ADDENDUM NO. 1

**HANOVER COMMUNITY SCHOOL CORPORATION - NEW RESOURCE
CENTER AND RELATED WORK
Cedar Lake, IN 46303**

This Addendum consists of page ADD 1-1 and attached Addendum No. 1 from Gibraltar Design dated May 27, 2021 and consisting of 5 pages and 48 drawings.

MAINTENANCE BUILDING ARCHITECTURAL ROOF PLAN
SCALE: 1/16" = 1'-0"

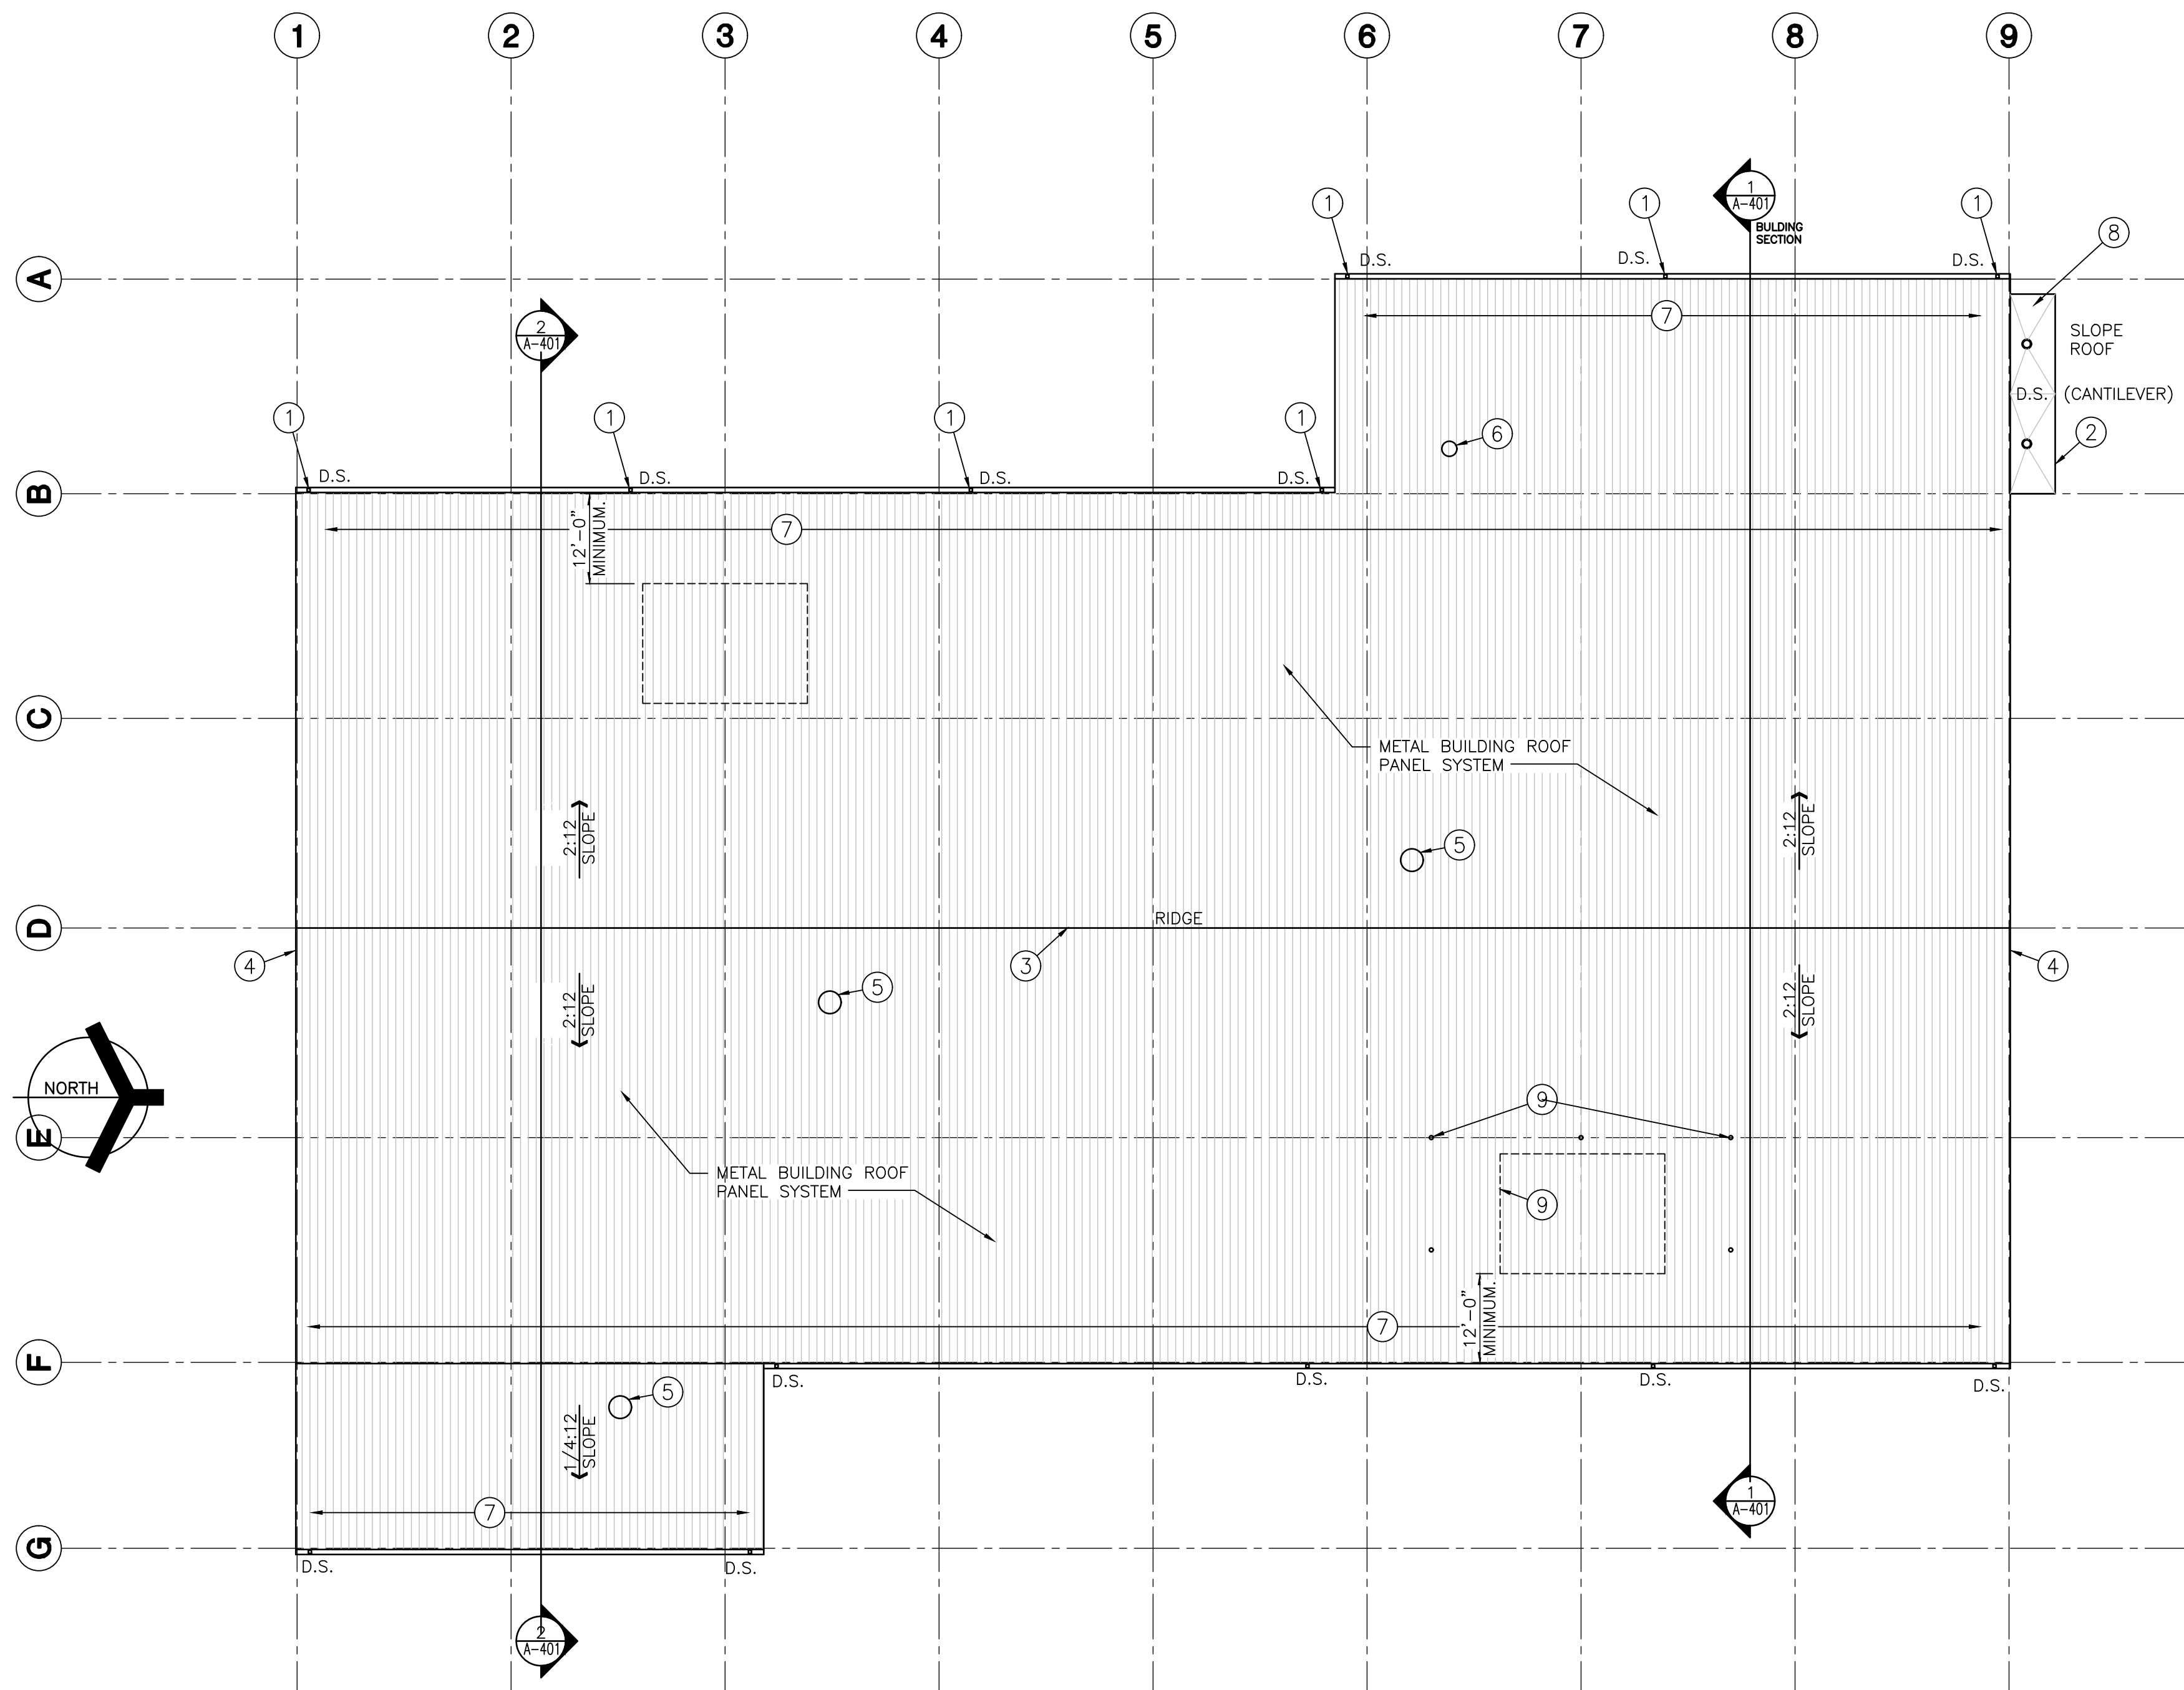
14. Sheet A-201 and A-301

- A. Refer to two (2) Full Size Drawing Sheets included in this Addendum for revisions.
